## ADDENDUM

Campus HVAC System Upgrade  
Mt. Vernon Elementary School  
Bakersfield City School District  
566-0015

Subject: Addendum #02

# Quam SYSTEM 12

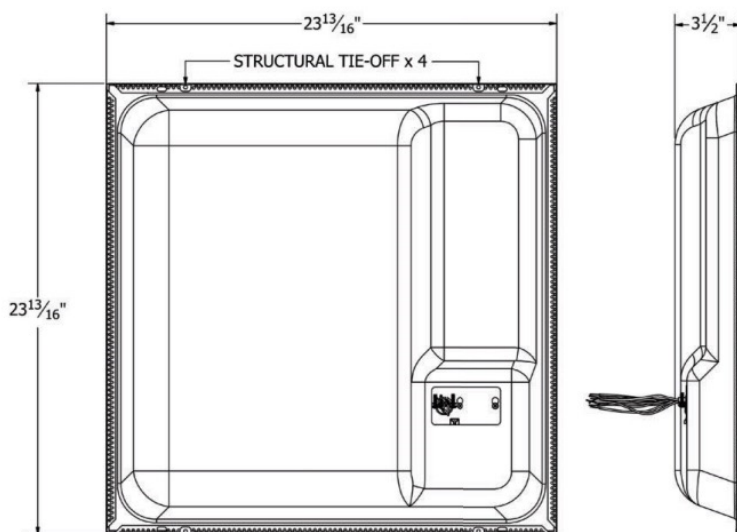
2.10.1.1 Ceiling mounted PA Speakers to be provided and installed in each classroom at Building B, C,D and E. Speaker to be **Quam System 12 2'x2' Loudspeaker**- see attached cut sheet/ spec.

Mt. Vernon Campus HVAC System Upgrade  
Existing Campus Network IDF Locations  
Addendum 02  
Drawing ADD 2.02

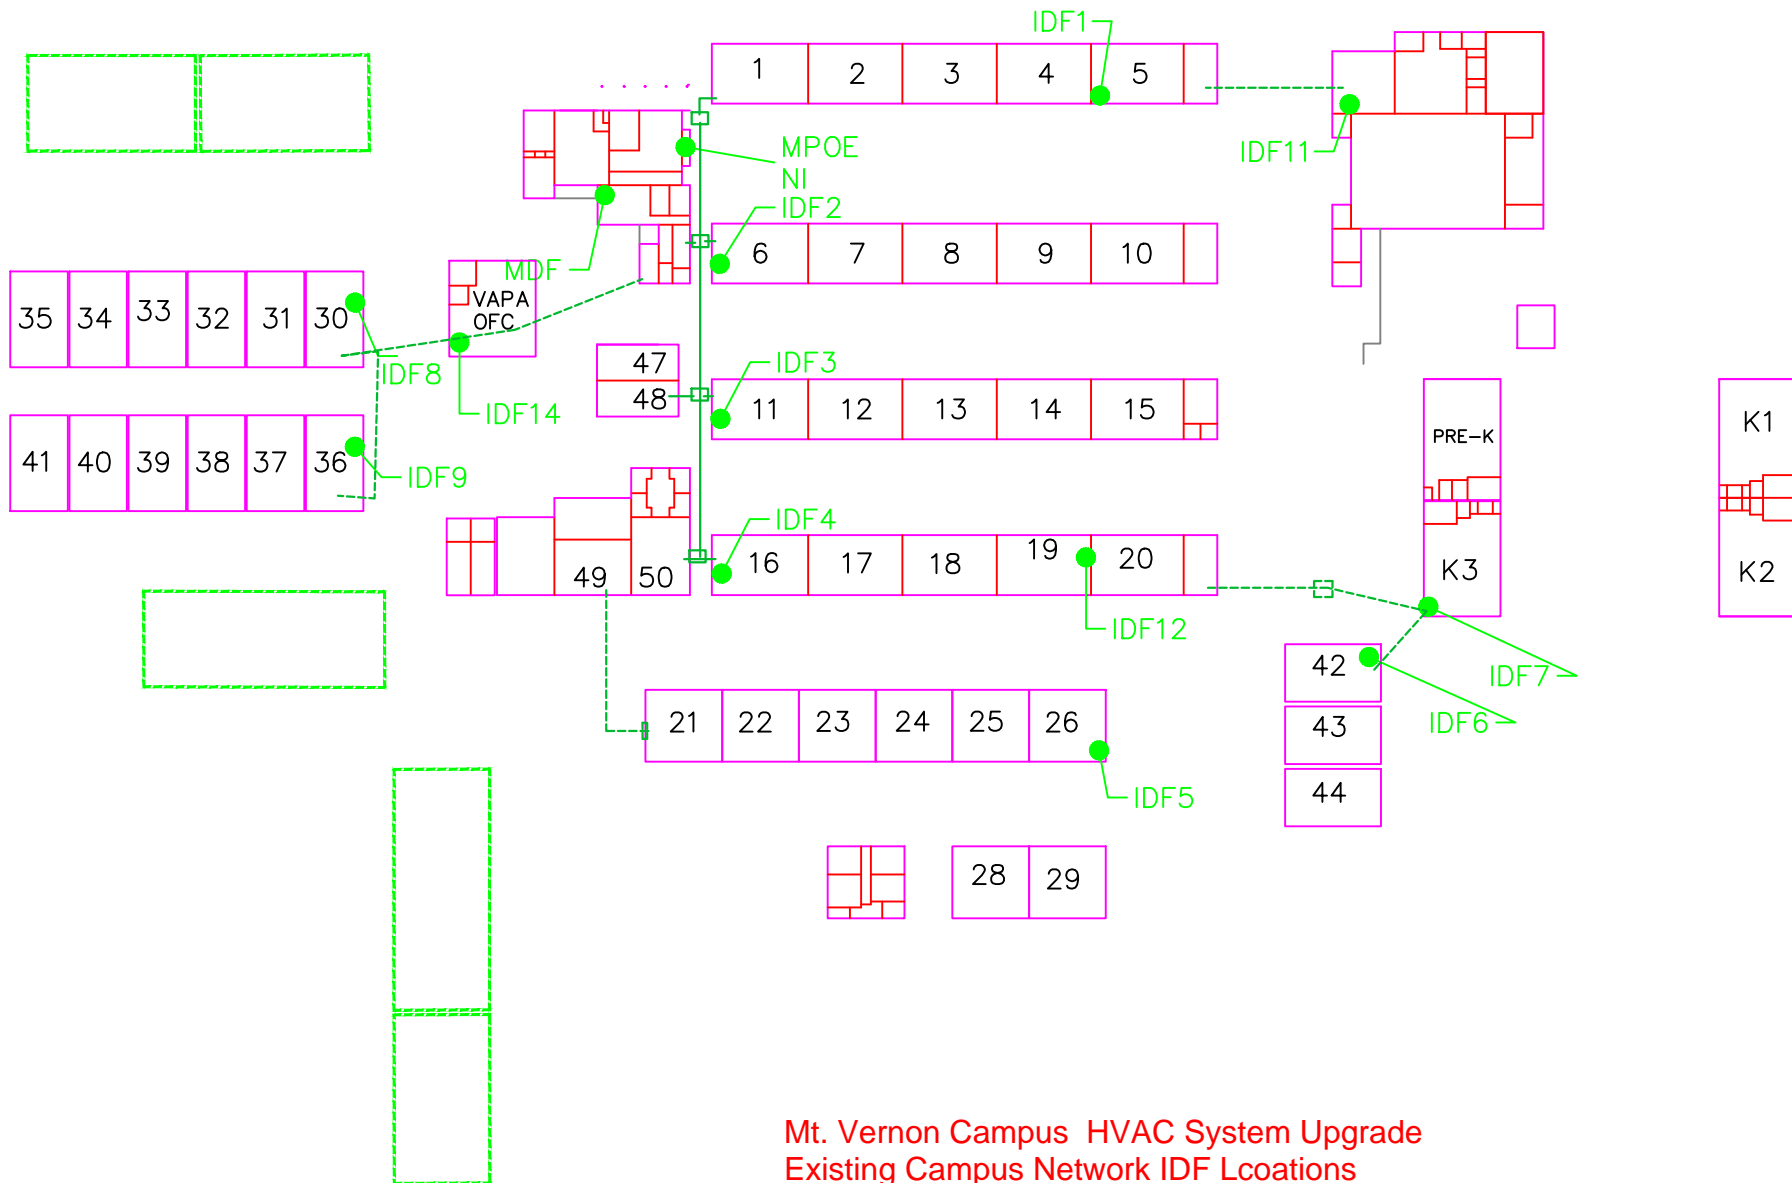
### **2.11 Refer to attached Addendum Drawing AD 2.02- Existing Campus Network IDF Locations:**

2.11.1 See attached Drawing ADD 2.02 Existing Campus Network diagram for IDF locations.

2.11.2 Contractor to remove and replace existing **IDF 1, IDF 2, IDF 3, IDF 4 and IDF 12**.

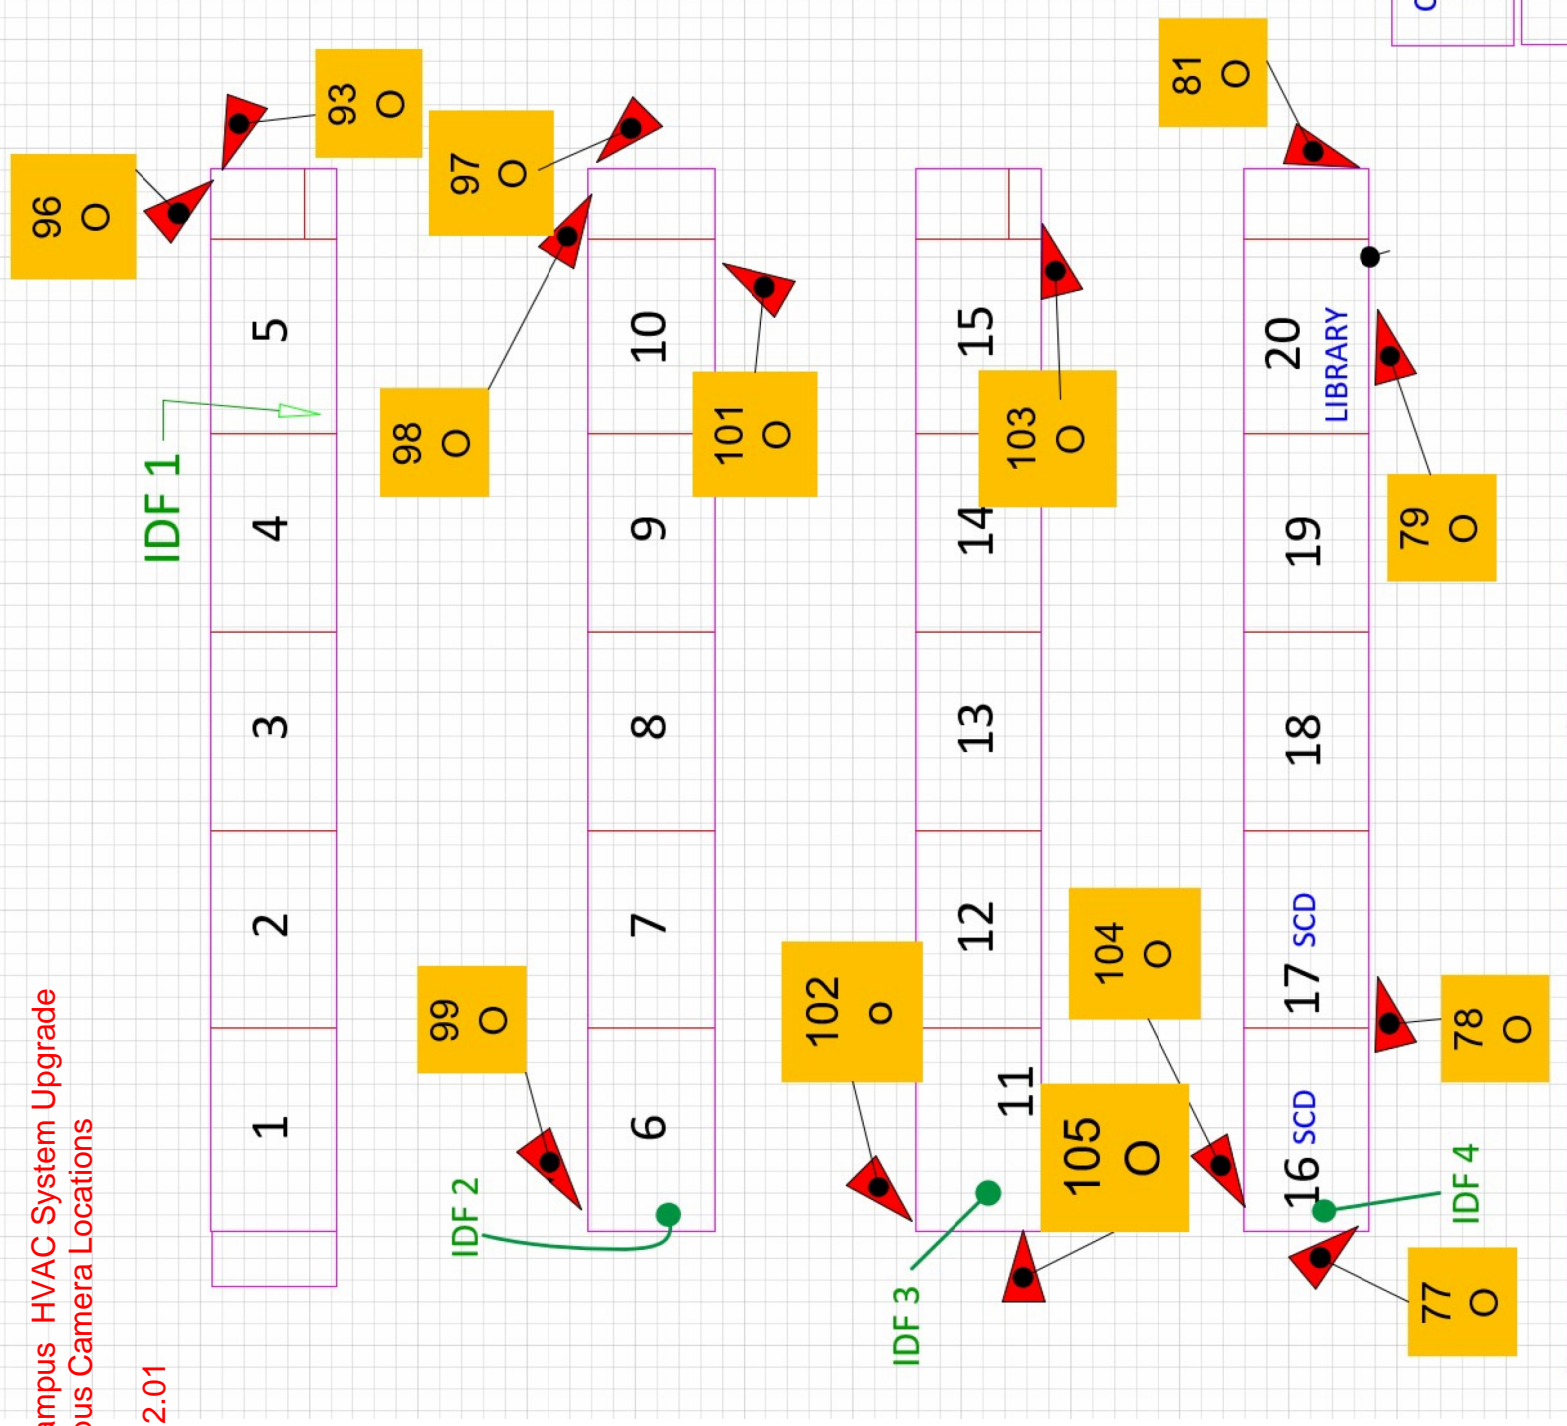
#### **2.1 Refer to Electrical Sheet E-001, Single Line Diagram and Electrical Notes:**

##### **2.1.1 Refer to LED FIXTURE SCHEDULE:**

2.1.1.1 Omit Fixture Type "E" and "EM". These fixtures will not be required on this project.
